**The San Clemente Dam Removal Option
A Review of Benefits to Steelhead Fisheries
and
Approaches to Sediment Management**

**National Marine Fisheries Service
Southwest Region - Santa Rosa Field Office
777 Sonoma Ave, Rm 325
Santa Rosa, CA 95404**

November 6, 2001

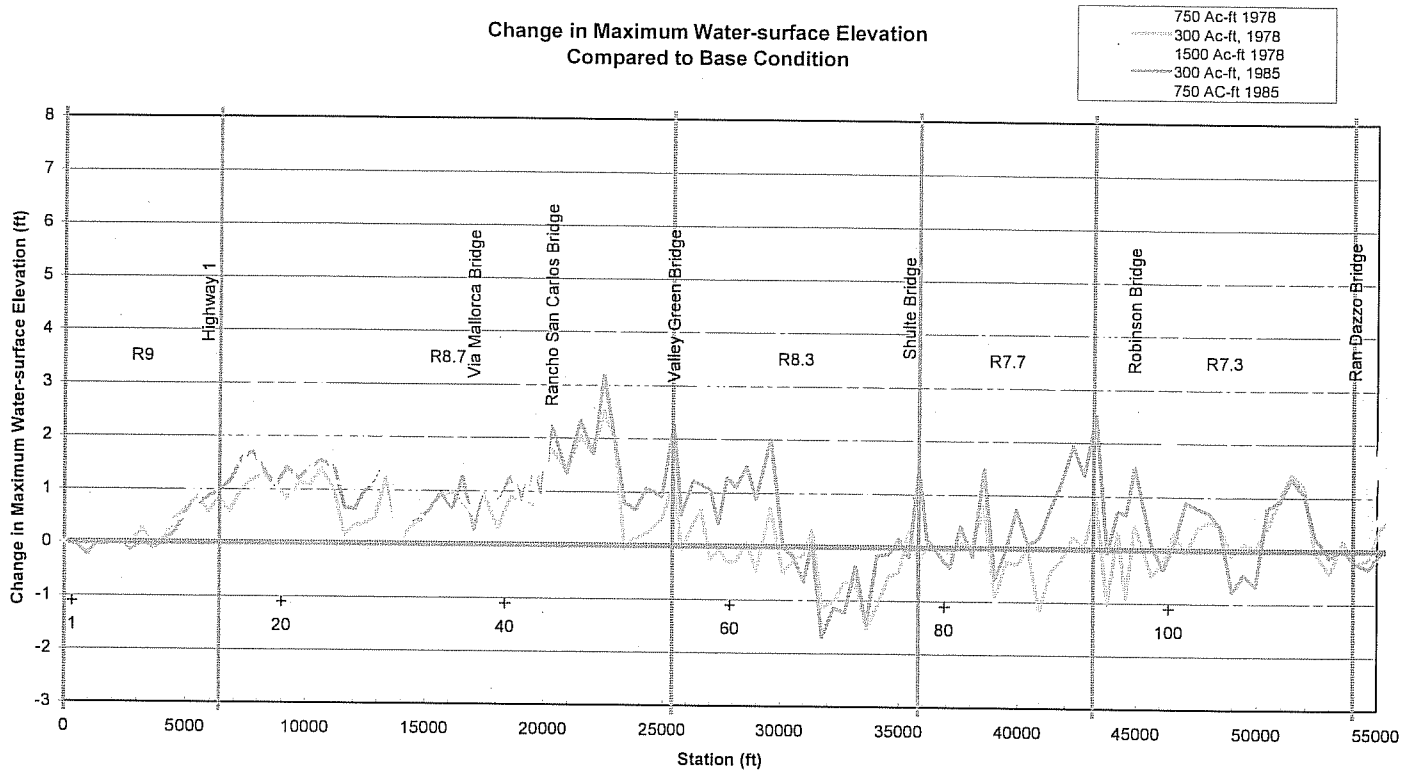
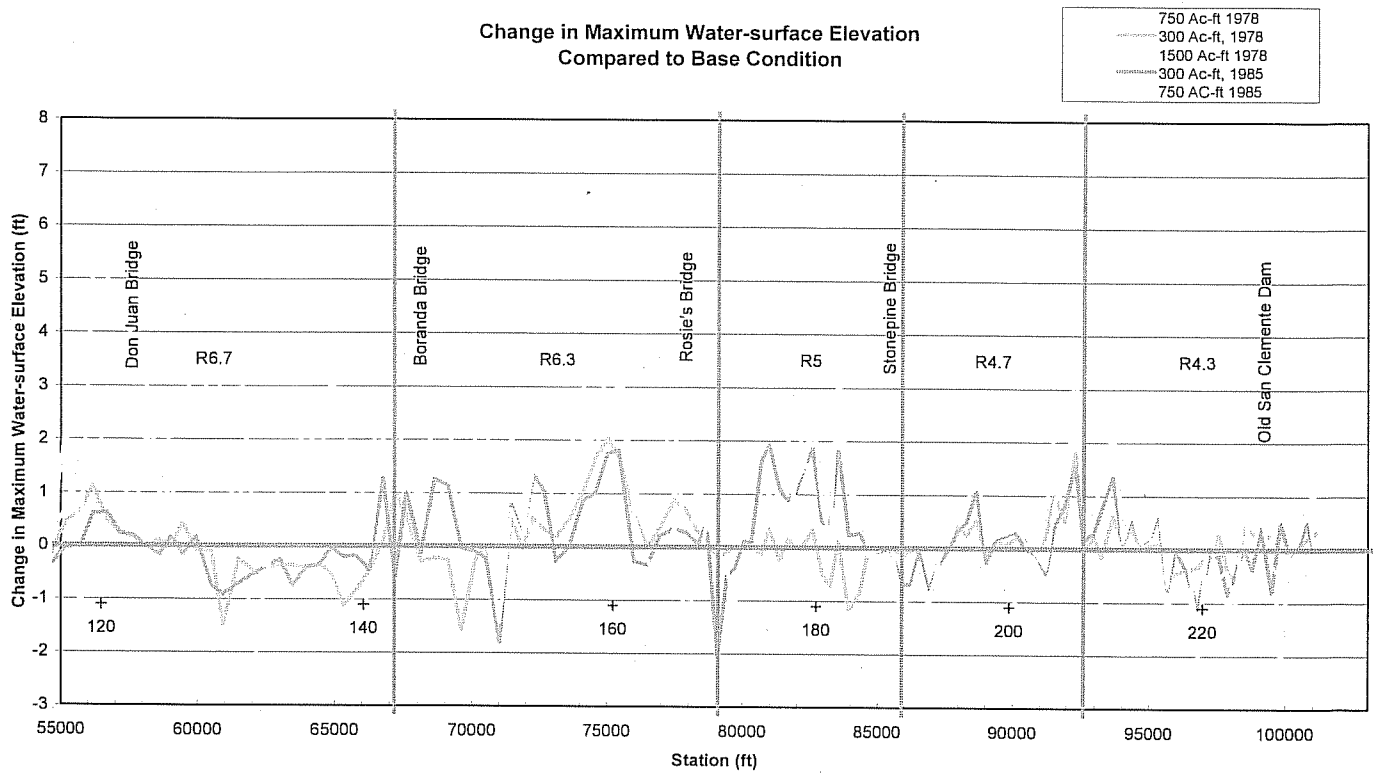
Model results show different effects of the various evacuation volumes and both starting hydrologic conditions (refer to Figures 2 and 3). The greatest modeled increase in water surface elevation occurs when 1500 AF of sediment is released under wet starting conditions (1978). (The dry starting condition 1500 AF scenario was not run). At River Mile (RM) 8.2, the maximum water surface change is approximately 5.9 feet during the simulation period. The 750 AF dry start scenario gives a change in water surface elevation of 4.9 feet at the same location. The 5-point running average difference between 1500 AF wet and 750 AF dry is approximately 1 foot over the majority of the river, with 2 feet being the greatest difference near RM 10.8. The water surface differences between the 750 AF wet model scenario and the 750 AF dry scenario exceed 3 feet for the entire distance from RM 4 to RM 10.

Similarly, the difference in maximum water surface elevation between 300 AF wet and 300 AF dry are greater than between 750 AF wet and 300 AF dry. These striking results of the modeling effort, to date, lead to the conclusion that the starting hydrology and sequence of floods have a greater influence on increased flooding potential than does the volume of sediment evacuated from the reservoir. The modeled change in maximum water surface elevation along the Carmel Valley is a complex response between antecedent channel conditions, and the location and shape of the sediment wedge as it moves downstream. Flood risk is the joint probability of (1) the timing and location of the sediment wedge at a critical point combined with (2) the probability of occurrence of the largest flood in the record.

To fully examine the potential feasibility of removing the SCD, additional analysis is needed. We recommend that the following evaluations be performed:

- 3) The HEC-6 model results should be used to identify critical channel maintenance locations downstream from SCD.
- 4) Additional model scenarios should incorporate mechanical removal of channel sediment accumulations in order to evaluate their downstream effects on flood elevations.

- 7) Additional HEC-6 model scenarios should be developed to accurately examine the downstream flooding effects and long-term ecological effects of the sediment
